Access Compliance Report

Public Rights-of-Way

Intersection ID: 11357	Main Street: W_TRADE_ST	Cross Street: N_IRWIN_AV	Location: N
ADA ID: D900A8643BE2	Ramp Type: Perp	Initial Pass/Fail: Pass	Overall Compliance: No
			Severity Score: 10.25

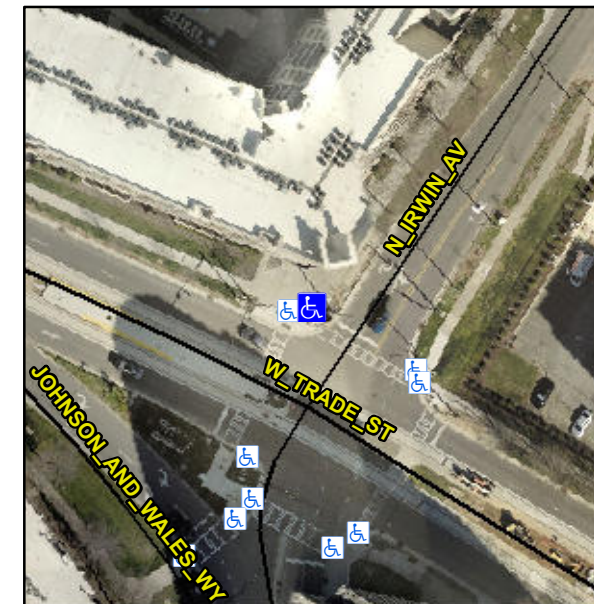
R304.5.3, R304.2.3, R305.2, R304.5.4

Compliance	Description	Data	Compliance	Description	Data
N/A	Ramp Length (in)	73.0	Yes	Ramp Slope (%)	6.0
Yes	Ramp Width (in)	57.0	No	Ramp XSlope (%)	4.9
No	Flare Type	Curbed_WithWalkSurface	Yes	Flare Type RT	N/A
No	Flare Slope LT (%)	N/A	N/A	Flare Slope RT (%)	N/A
N/A	Flare Traversable LT?	No	N/A	Flare Traversable RT?	No
Yes	Landing Length (in)	60.0	Yes	DWS Provided?	Yes
Yes	Landing Width (in)	60.0	Yes	DWS Contrast?	Yes
Yes	Landing Slope (%)	1.4	Yes	DWS Length (in)	24.0
No	Landing X Slope (%)	3.2	Yes	DWS Full Width?	Yes
N/A	Landing Curb? (Y/N)	No	No	DWS Offset (in)	5.0
N/A	Shared Landing?	No			
Yes	Gutter Ponding?	No	No	Gutter Slope (%)	6.6
Yes	Gutter Lip Ht (in)	0.0	No	Gutter X Slope (%)	3.8
N/A	Painted X Walk1?	Yes	N/A	Painted X Walk2?	N/A
	X Walk 1 Direction	To SE		X Walk 2 Direction	N/A
N/A	X Walk 1 Width (in)	63.0	N/A	X Walk 2 Width (in)	N/A
	X Walk 1 Slope (%)	4.4		X Walk 2 Slope (%)	N/A
	X Walk 1 X Slope (%)	1.3		X Walk 2 X Slope (%)	N/A

**Remove & Replace Entire Ramp.
Remove & Replace Gutter.**
